Addendum Number: 04

Addendum Issue Date: February 8, 2021

Project Name: CMH Ortho Clinic Addition and Renovation

Project Number: 0200707.00

GENERAL NOTES

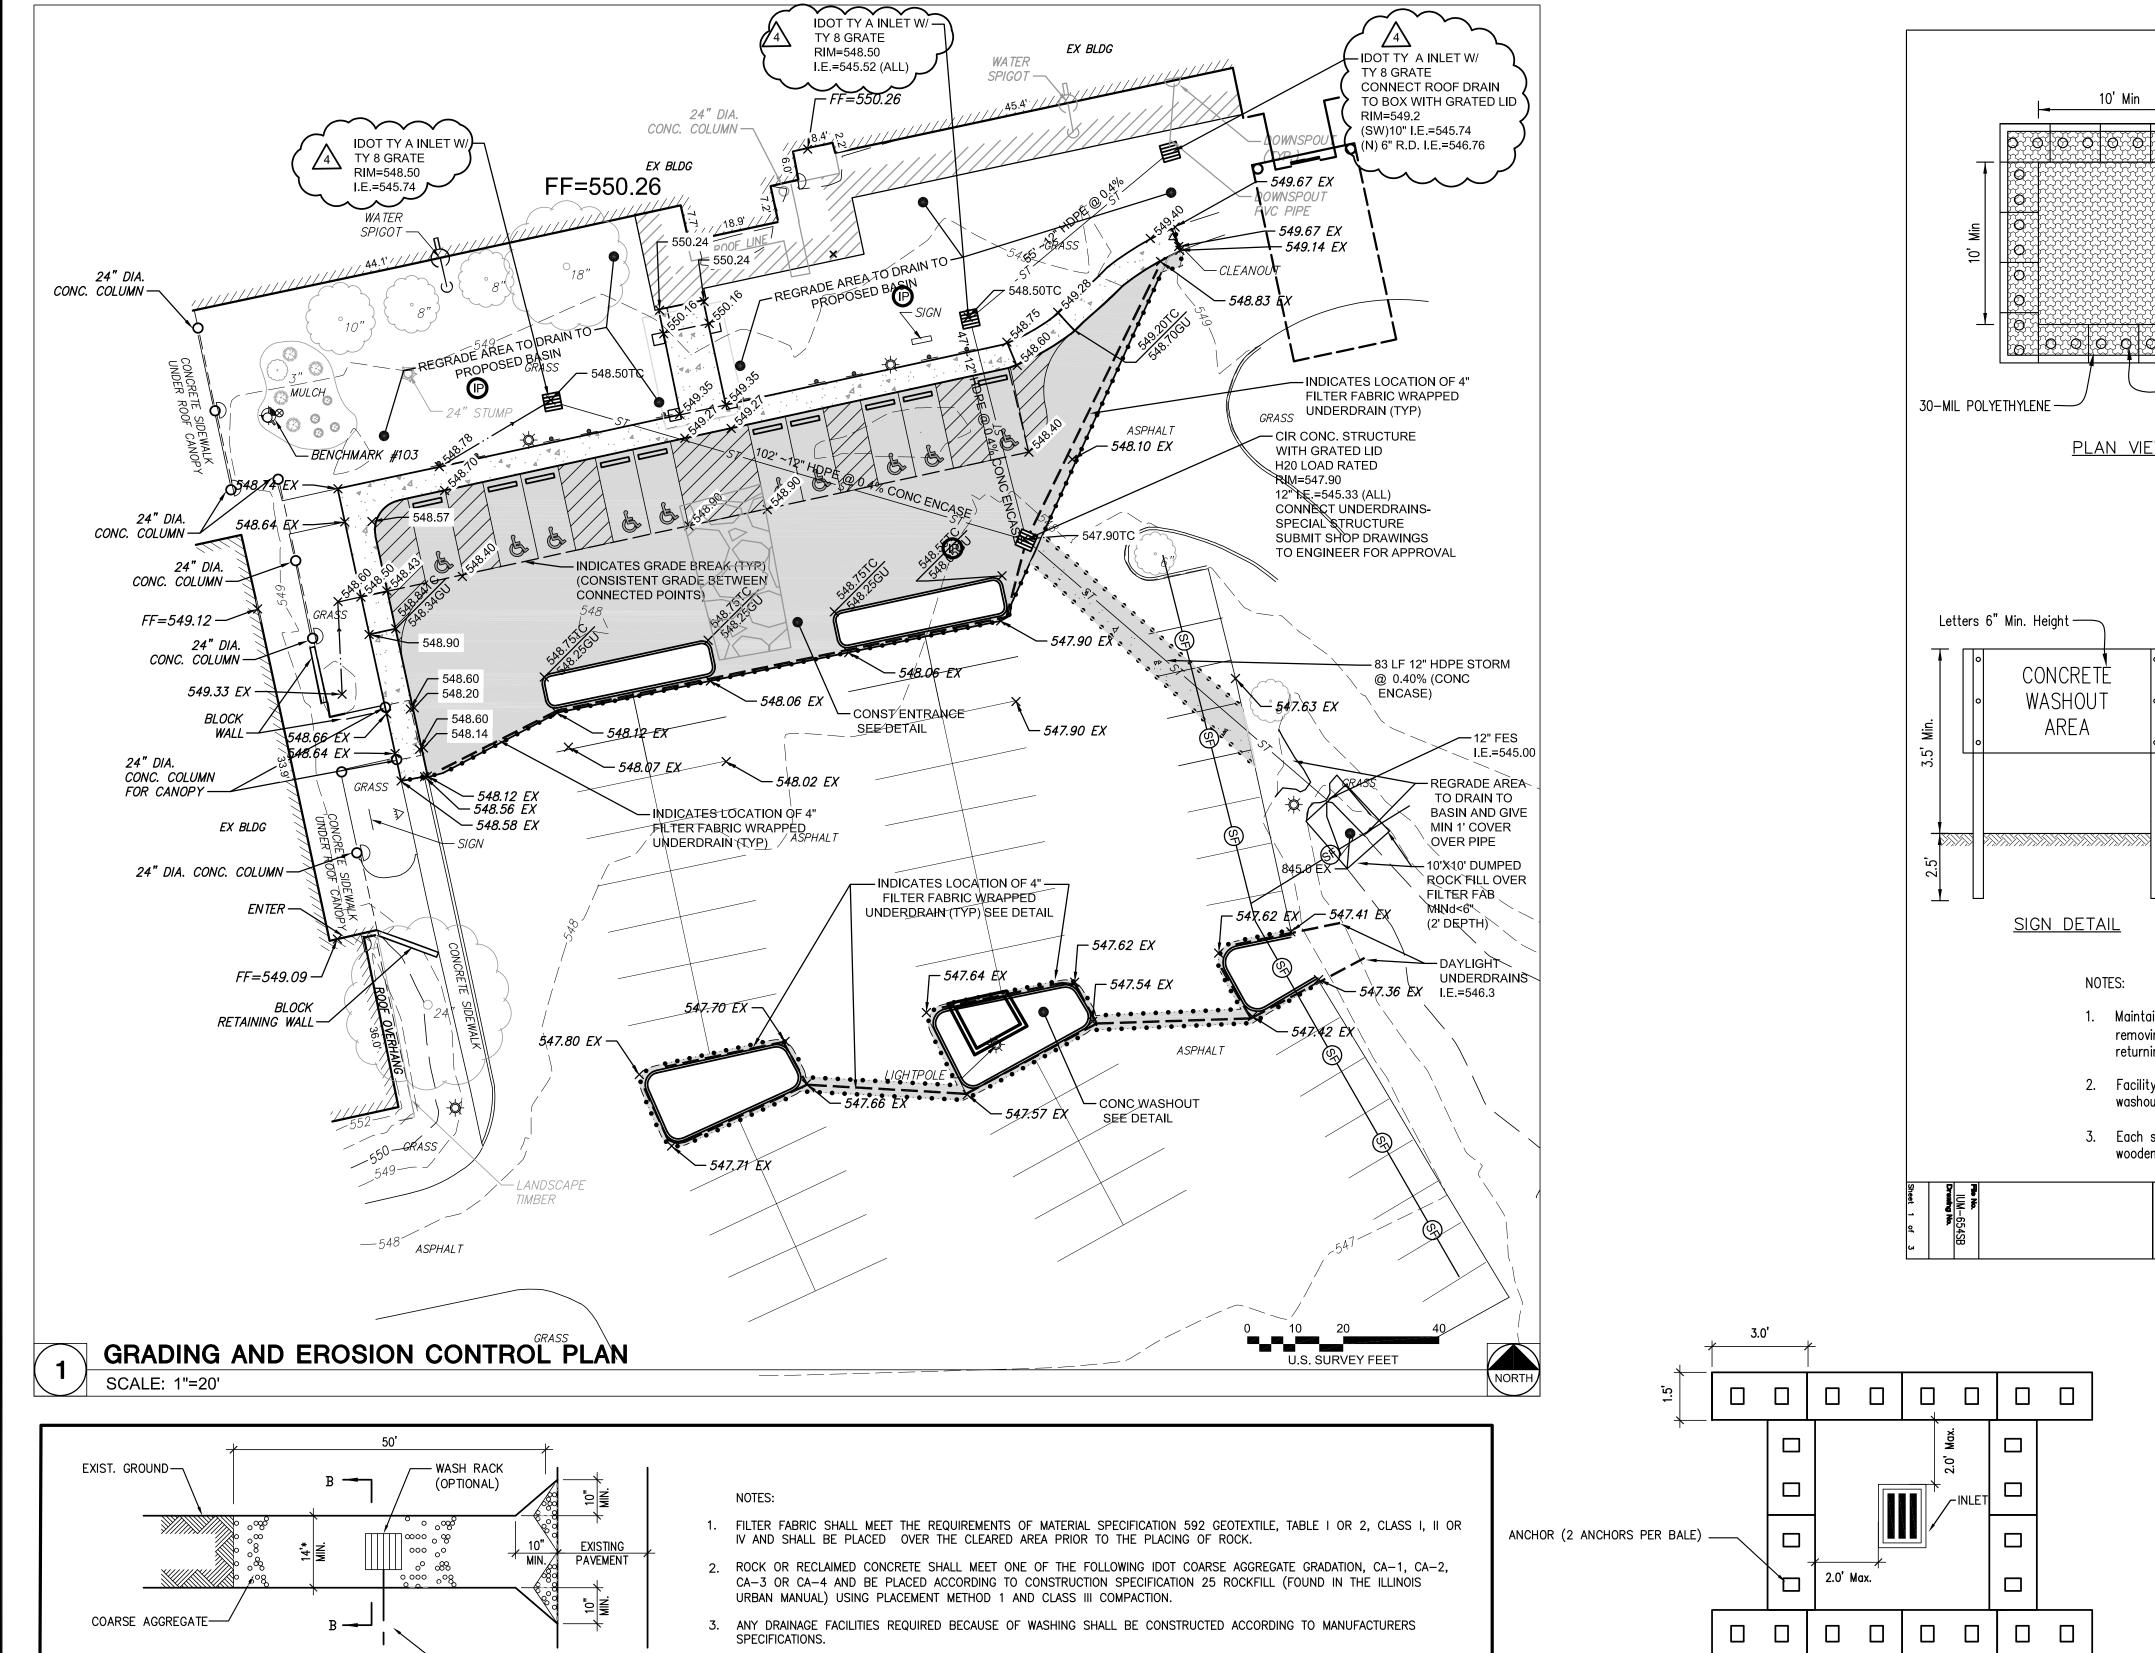
- 1. Sheet C0.1 GENERAL NOTES
 - a. REVISE utility contacts. See the attached reissued sheet.
- 2. Sheet C3.0 GRADING AND EROSION CONTROL PLAN
 - a. REVISE inlet structures from type B to type A and change the grate from type B to type 8, as per the attached reissued sheet.
